Work Order ID 92846

Item Name: Crosstube Fwd High

DRAWING NO. D212-664-141	TITLE XTUBE ASSY (205/212/412 HI FWD)	REV. D	DART AEROSPACE LTD ENGINEERING ORDER		D.E.O. NO. D212-664-141-D-1	SHEET NO. SHEET 1 OF 2	SCALE NTS
DRAWN	CHECKED	MFG. APPR.	APPROVED	DE APPR.			
DATE 11.04.07	DATE 11.04.11	DATE 11.04.12	DATE 11/04/12	DATE 11.04.12

DRAWING NO. D212-664-141	TITLE CROSSTUBE ASS'Y (205 HI FWD)	REV. D	DART AEROSPACE LTD ENGINEERING ORDER		D.E.O. NO. D212-664-141-D-2	SHEET NO. SHEET 1 OF 1	SCALE NTS
DRAWN <i>UP</i>	CHECKED <i>ADS</i>	MFG. APPR. <i>BS</i>	APPROVED <i>MP</i>		DE APPR. <i>TH</i>		
DATE 11.07.15	DATE 11.07.20	DATE 11.07.21	DATE 11/07/21		DATE 11.07.21

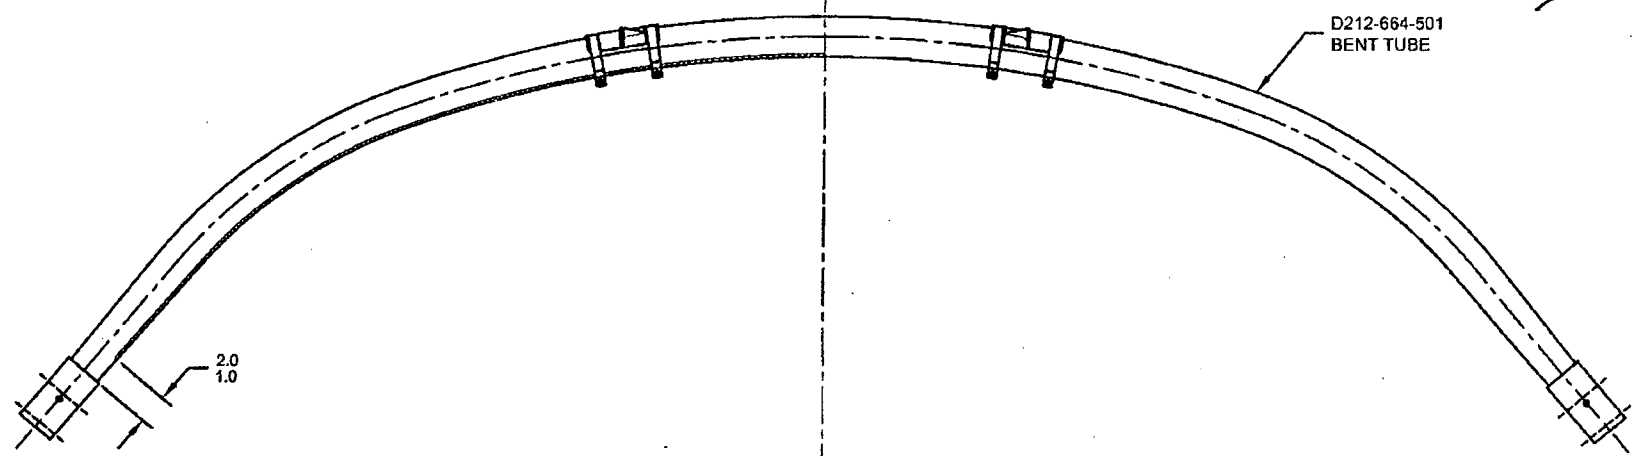
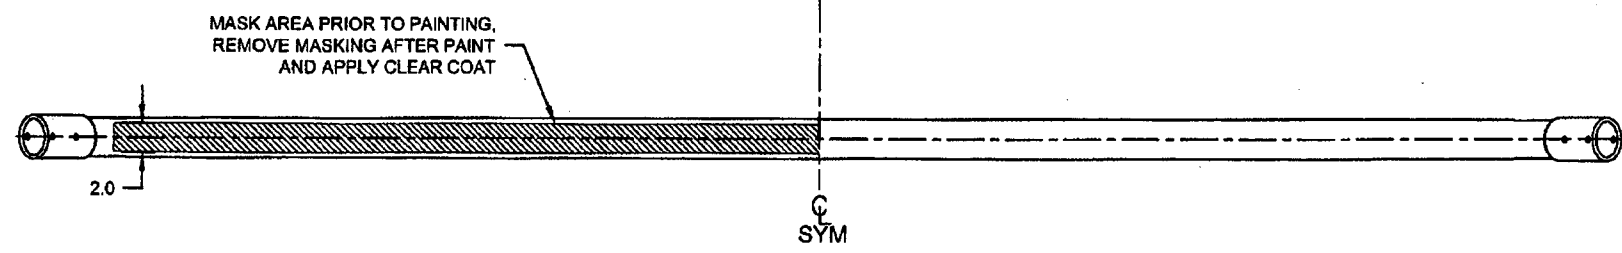
ADD AN INSPECTION WINDOW TO UNDERSIDE OF CROSSTUBE.

NOTES 2 OF SHEET 1 IS AMENDED AS FOLLOWS:

- 2) FINISH: CHEMICAL CONVERSION COAT PER DART QSI 005 4.1  
PRIME INSIDE AND OUTSIDE PER DART QSI 005 4.2  
MASK UNDERSIDE OF CROSSTUBE AS SHOWN (HATCHED AREA) AND  
PAINT OUTSIDE PER DART QSI 005 4.2  
REMOVE MASKING AND APPLY CLEAR COAT
